## DOOR LATCH BROKEN

**MODELS INVOLVED:**

All condense dryers and heat pump dryers with plastic door latch

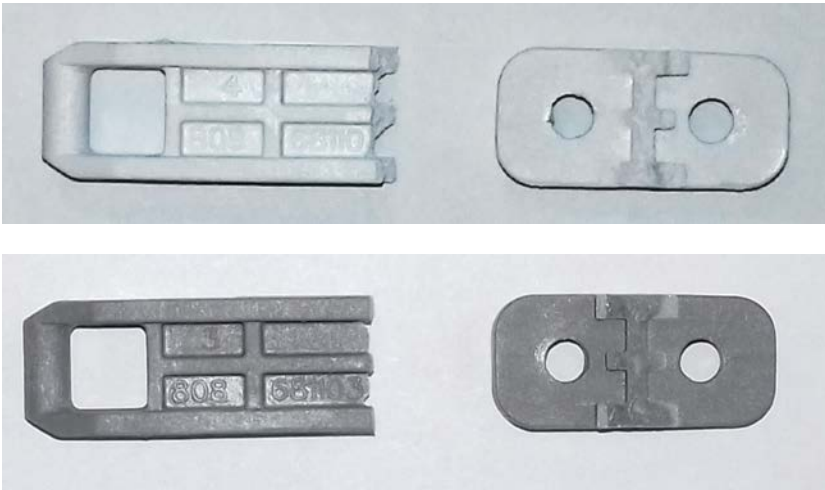
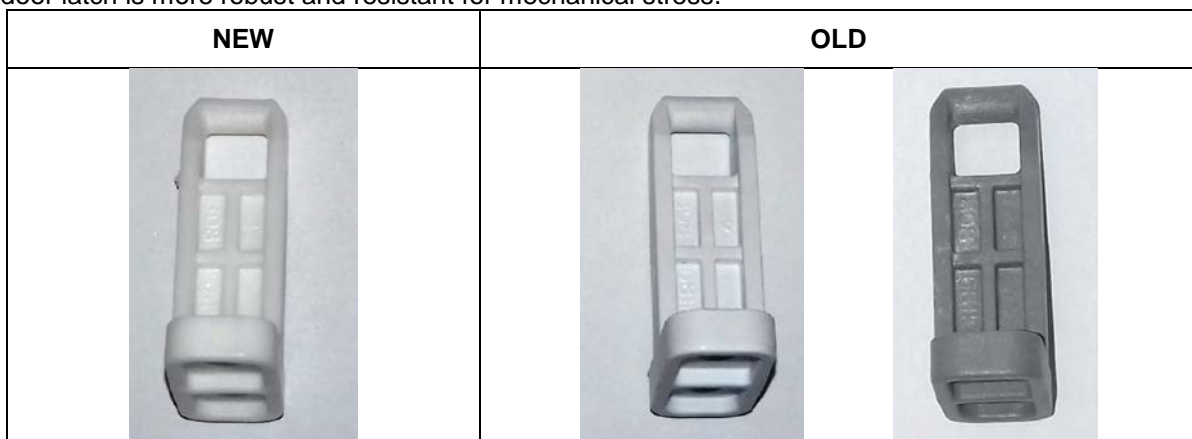
Consumer reports that the door latch is broken. Problem can occur due to mechanical stresses in the material.

Replace the broken door latch with a new spare part:

| Spare part number | Description                         |
|-------------------|-------------------------------------|
| 8086811083        | catch, porthole, glass door, Pilot2 |

New door latch is more robust and resistant for mechanical stress.
